Docket Number:	22-BSTD-01
Project Title:	2025 Energy Code Pre-Rulemaking
TN #:	246176
Document Title:	Pierre Delforge Comments - NRDC Comments on Building Energy Code Compliance Modeling Software
Description:	N/A
Filer:	System
Organization:	Pierre Delforge
Submitter Role:	Public
Submission Date:	9/22/2022 12:54:40 PM
Docketed Date:	9/22/2022

NRDC Comments on Building Energy Code Compliance Modeling Software

TO: CEC Buildings Standards Office
FROM: Pierre Delforge, NRDC
SUBJECT: CBECC 2022 Modeling Summary and Recommendations
DATE: September 22, 2022

Large Office – VRF

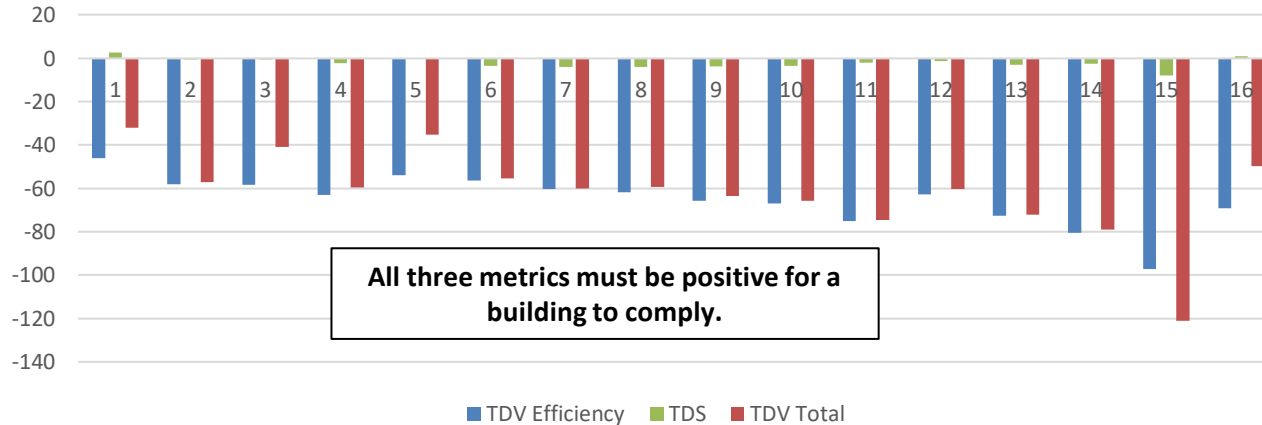
Similarly, the large office with the VRF system did not comply and, surprisingly, performed worse than the heat-pump VAV system with electric resistance reheat. The VRF system did not comply on both the TDV and TDS metric in almost every climate zone, as shown in Figure 2. Notably, the VRF system had higher energy use across multiple end-uses (heating, cooling, and fan energy use) and in particular had average fan energy use that was 4 times greater than the baseline VAV system.

- The ability to model air-to-water space heating heat pumps, heat recovery chillers, and integrated storage.
- The need for improvements to the VRF modeling capabilities to better reflect real world performance. These improvements include both a need to update the underlying performance curves as well as the way fan energy use is modeled.

Large Office – VRF Site Energy End Uses

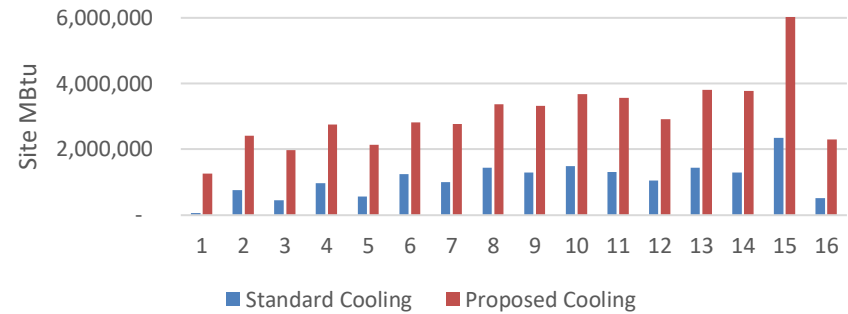
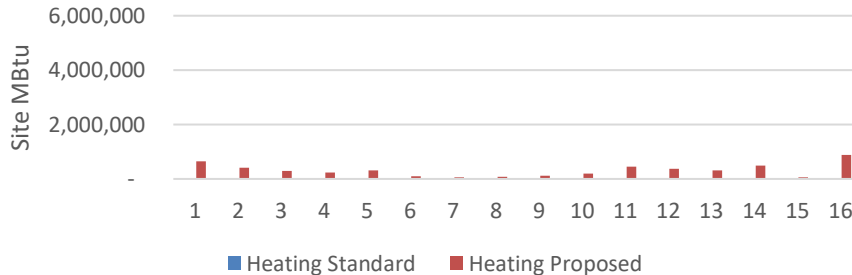
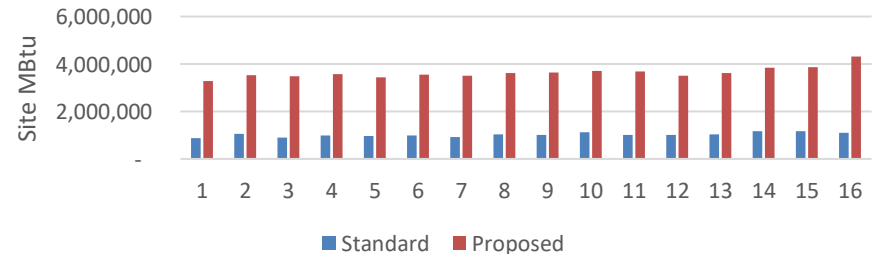
- These graphs compare the standard and proposed design modeled energy use using a common metric of site BTU.
- All three end-uses increased significantly, with cooling and fan energy driving non-compliance.

- There continues to be no feasible path to beat the gas built up VAV system baseline for large commercial buildings
- Highlights the need for modeling of air-to-water heat pumps
- Packaged HP system non-compliance driven by heating energy use (likely due to ER reheat)
- VRF non-compliance driven by higher energy use across multiple end-uses: Heating, Cooling, and Fan Energy Use
 - Average fan energy use of the VRF system is 4x greater than that of the baseline system.
 - Comparative performance of VRF system to packaged HP VAV system with electric resistance reheat does not seem to align with real world performance
